**CITY OF OREGON  
OREGON, OHIO  
WATER TREATMENT PLANT – CONCRETE REPLACEMENT PROJECT**

**Addendum No. 2  
May 8, 2024**

To: Prospective Bidders  
From: **ARCADIS U.S., Inc.**  
**One Seagate, Suite 700**  
**Toledo, Ohio 43604**  
Owner: **City of Oregon**  
**Department of Public Service**  
**5330 Seaman Road**  
**Oregon, Ohio 43616**  
Subject: **Water Treatment Plant – Concrete Replacement Project**

DRAWING NO.:  
S10-03

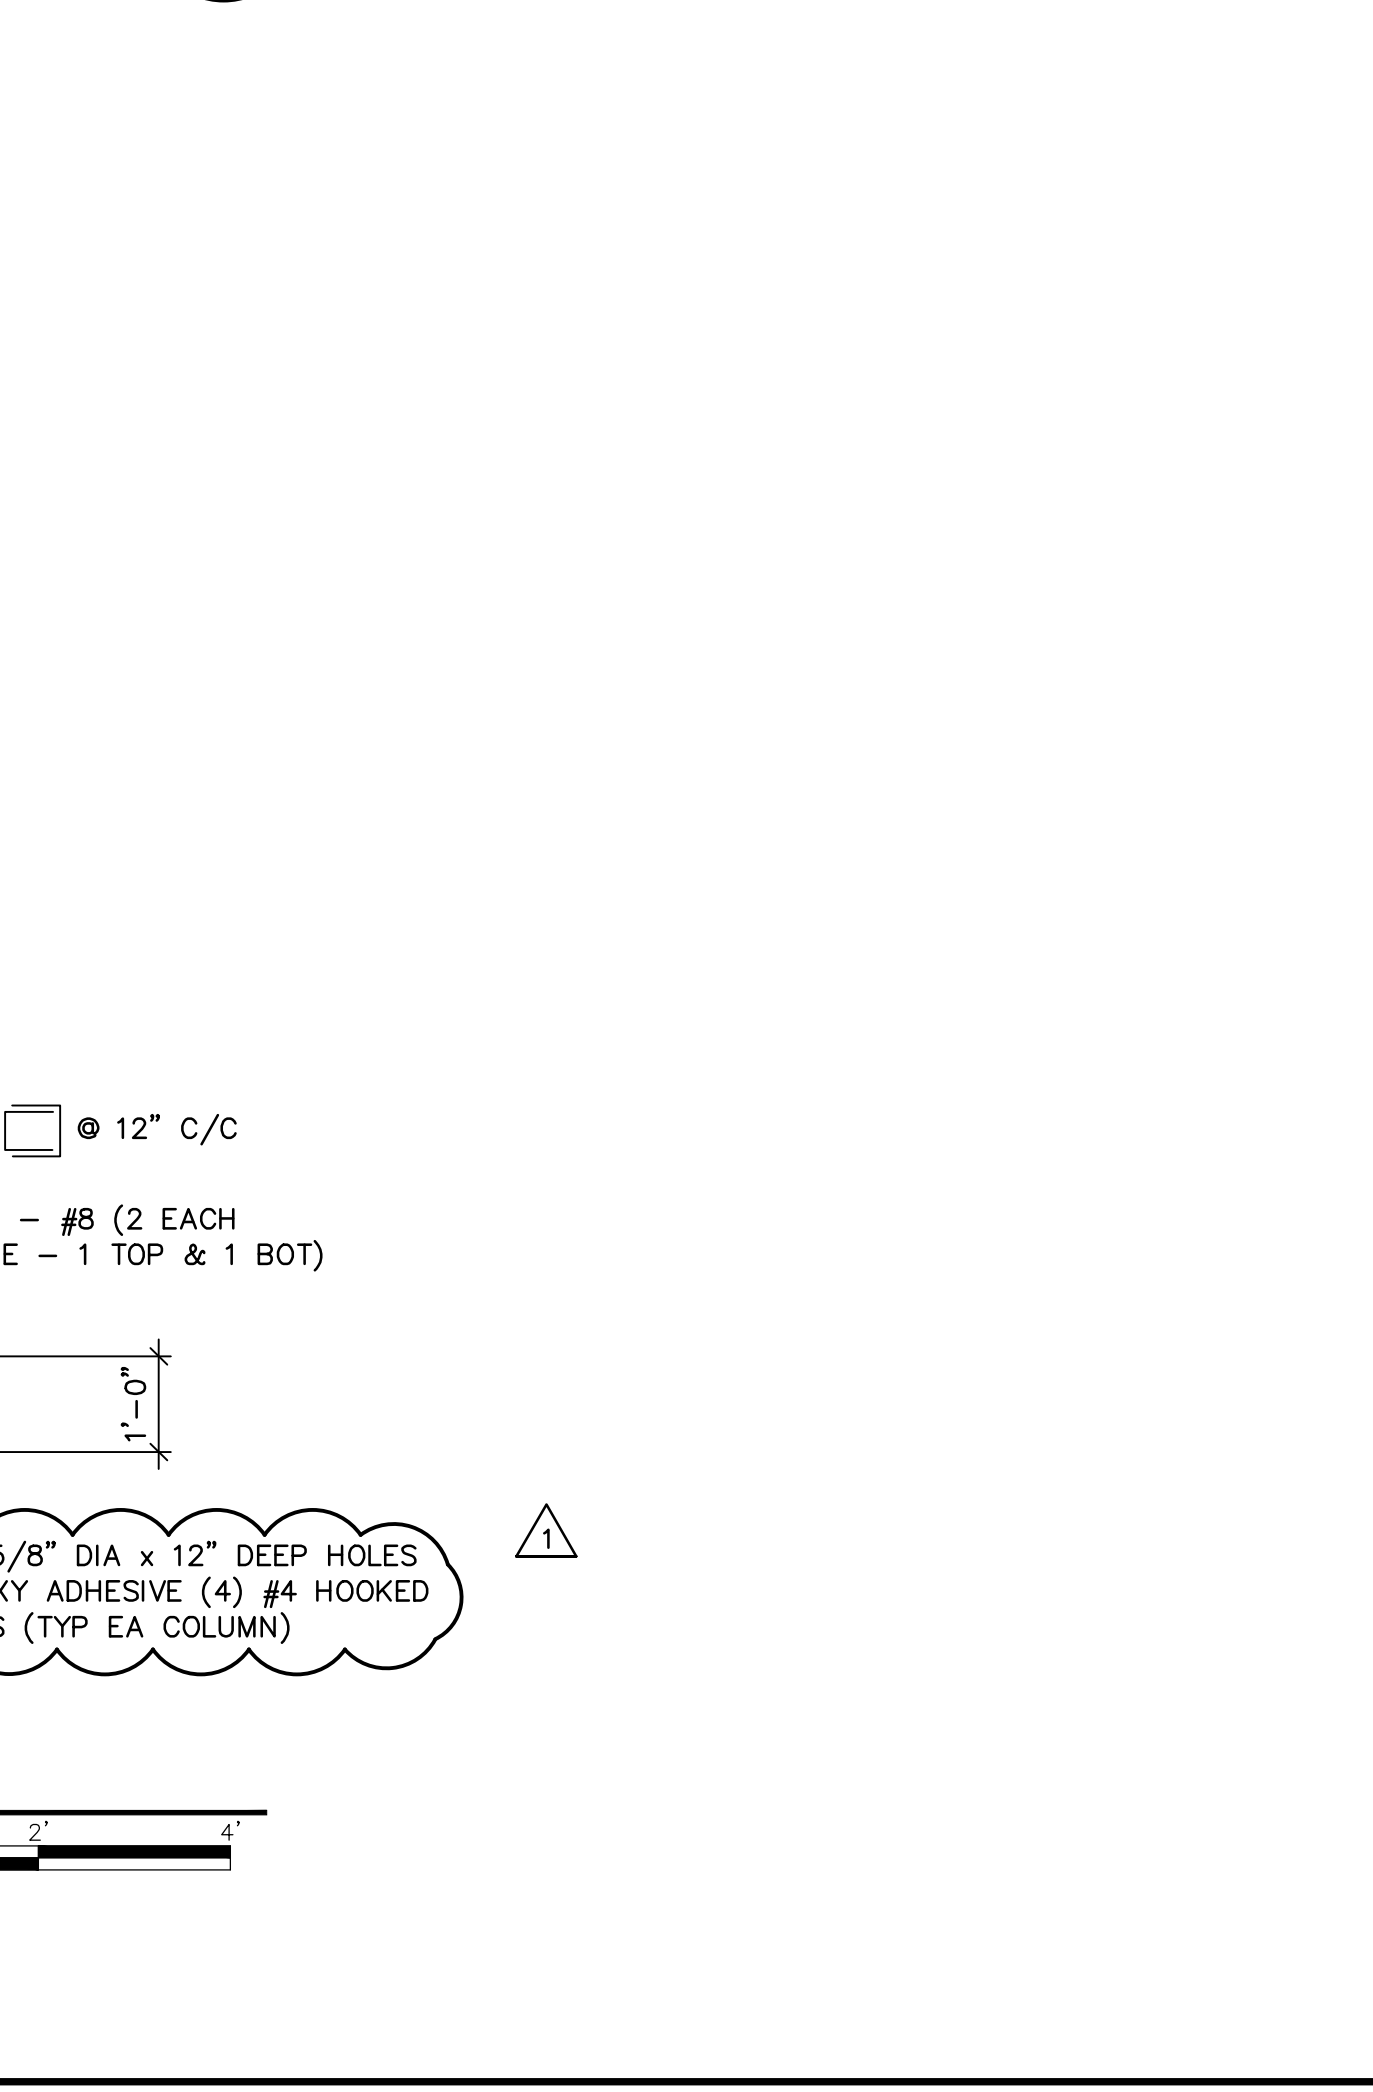
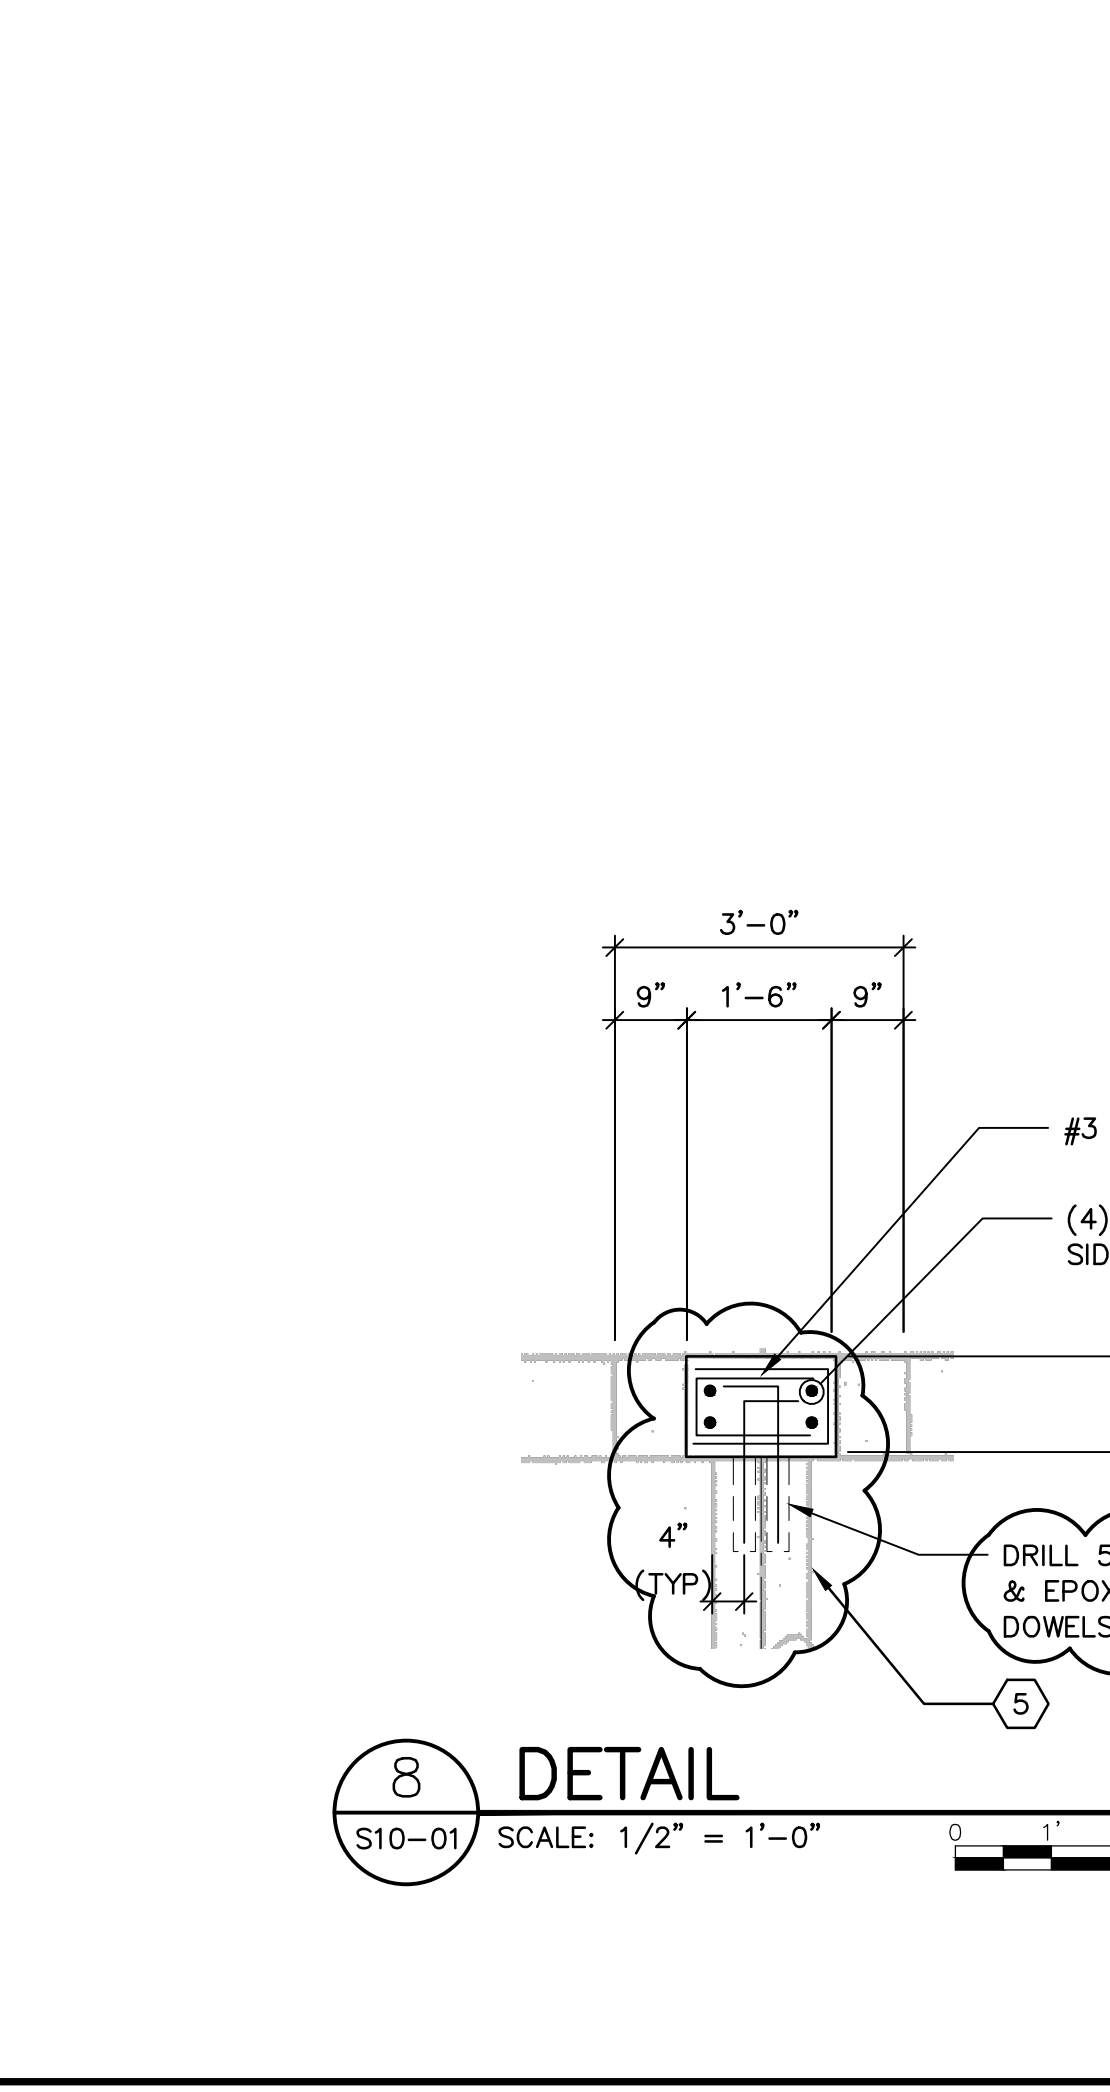
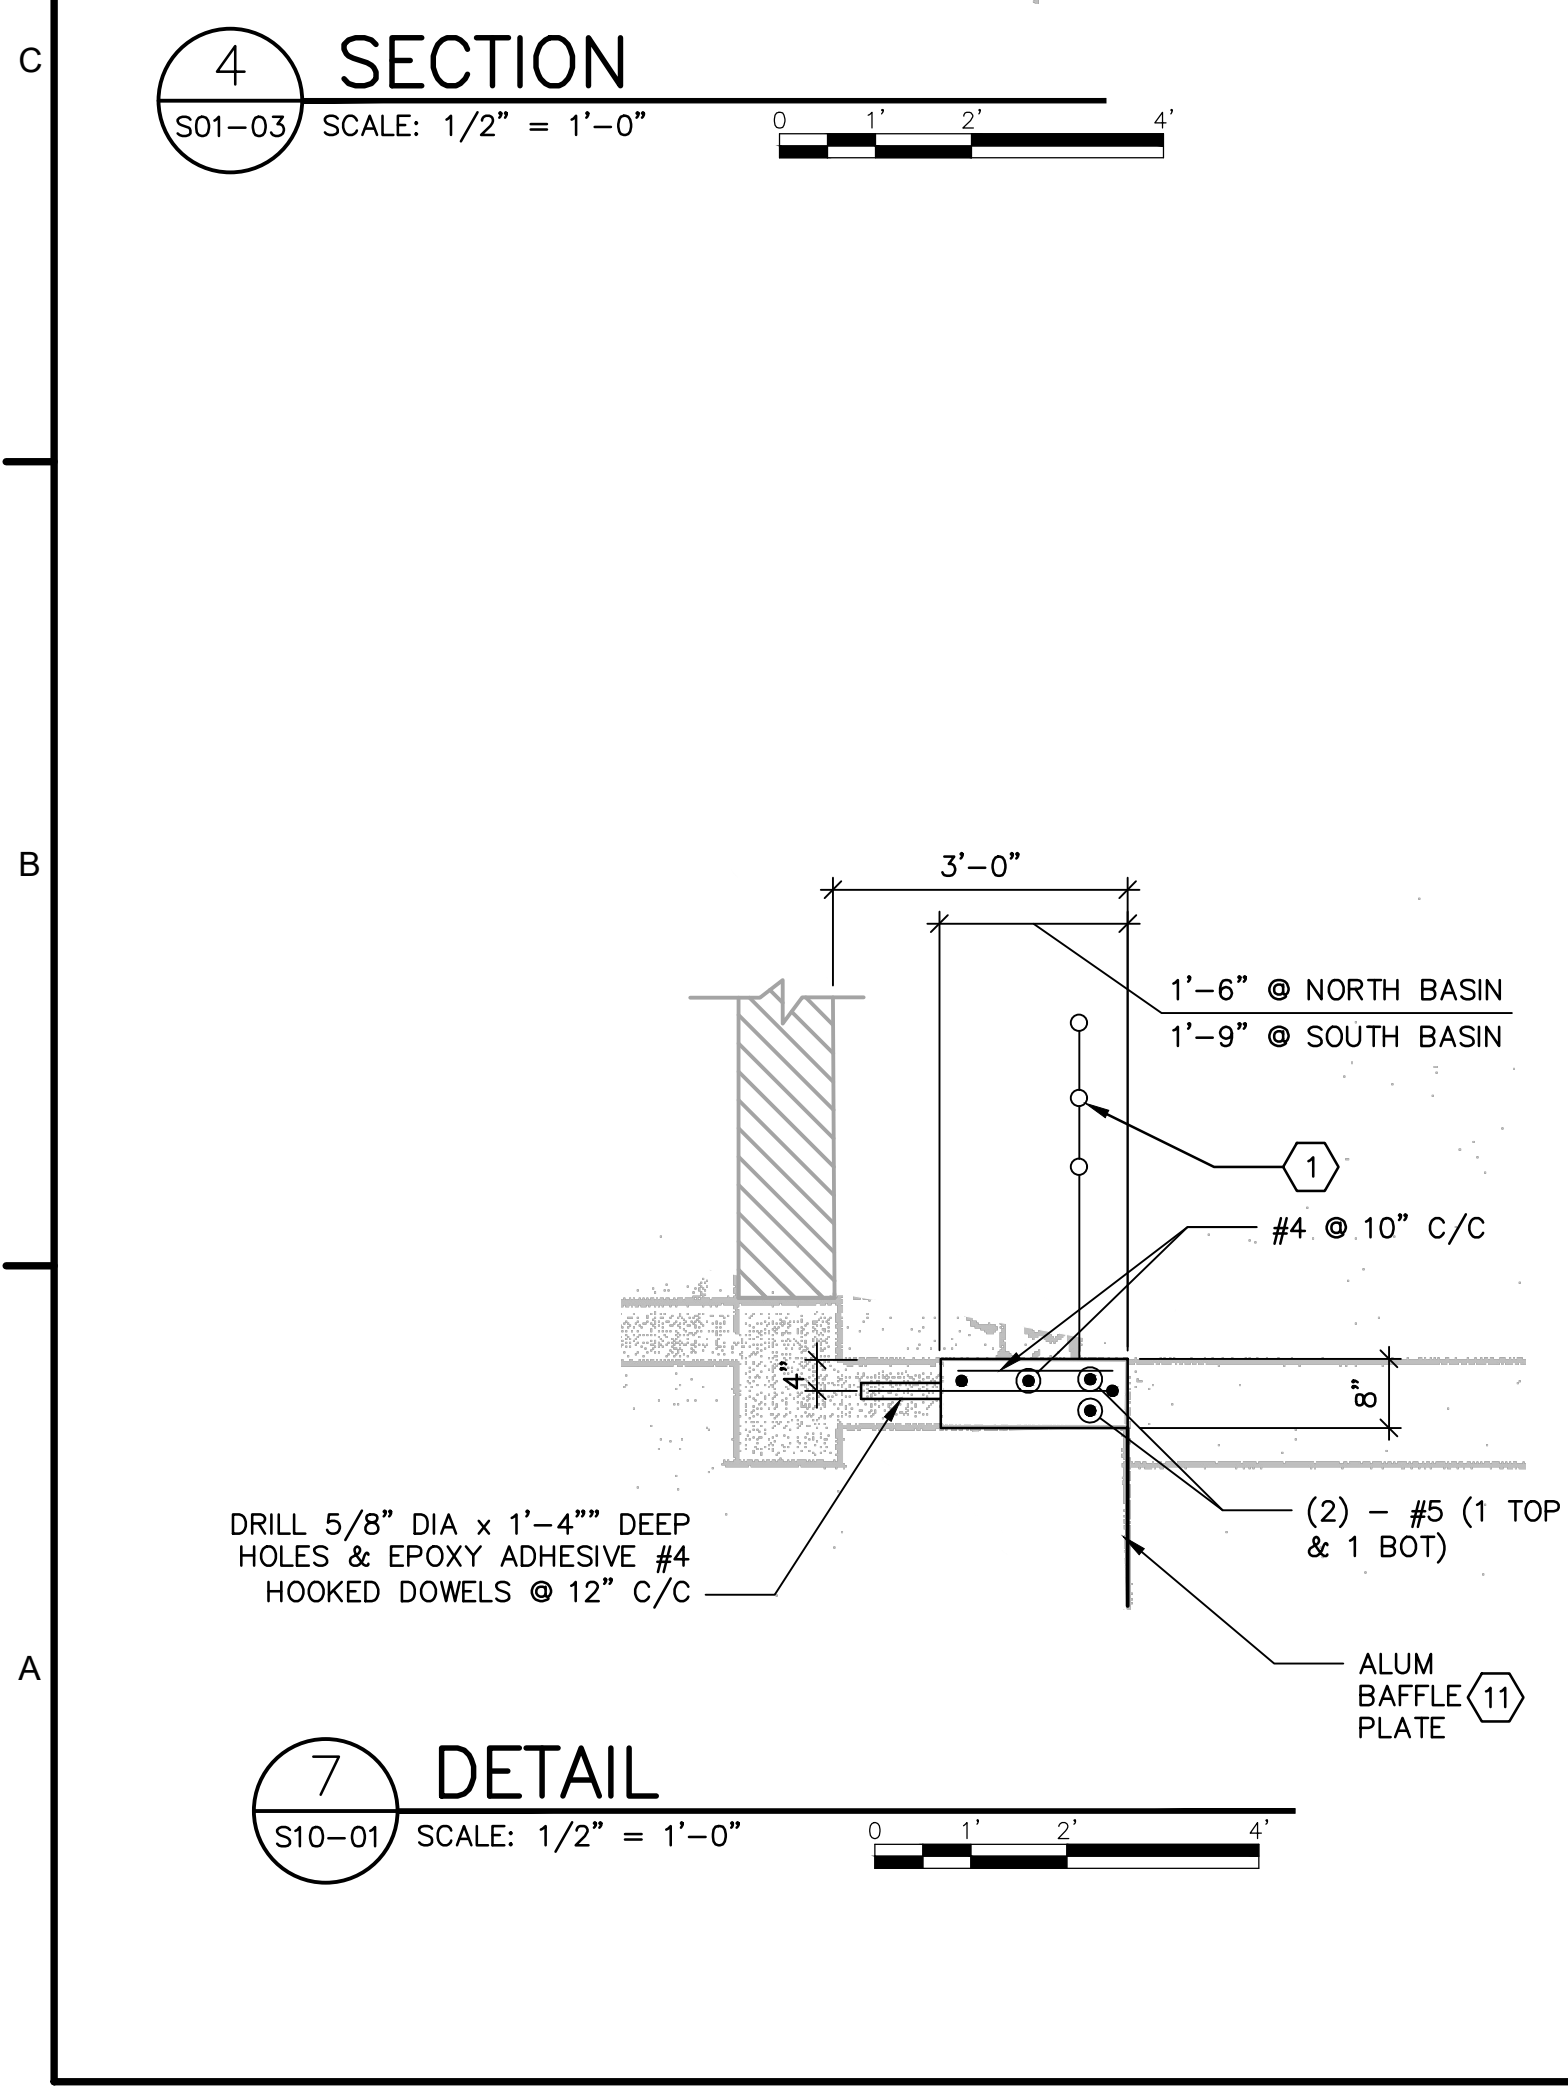
- 1.25 Drawing S10-03, SEDIMENTATION AND RECARBONATION BASINS (NORTH & SOUTH) – SECTIONS AND DETAILS - Delete this sheet in its entirety and substitute revised Drawing S10-03, included with this Addendum No. 2.

15. Can you please advise if the new 1'-6" wide struts in the Sedimentation Basins are to be doweled into the existing columns? Detail 8 on drawing S10-03 does NOT appear to show any dowels being required.

Response: Yes, as shown in Detail 8 on Drawing S10-03 that has been revised and re-issued in Addendum No. 2.
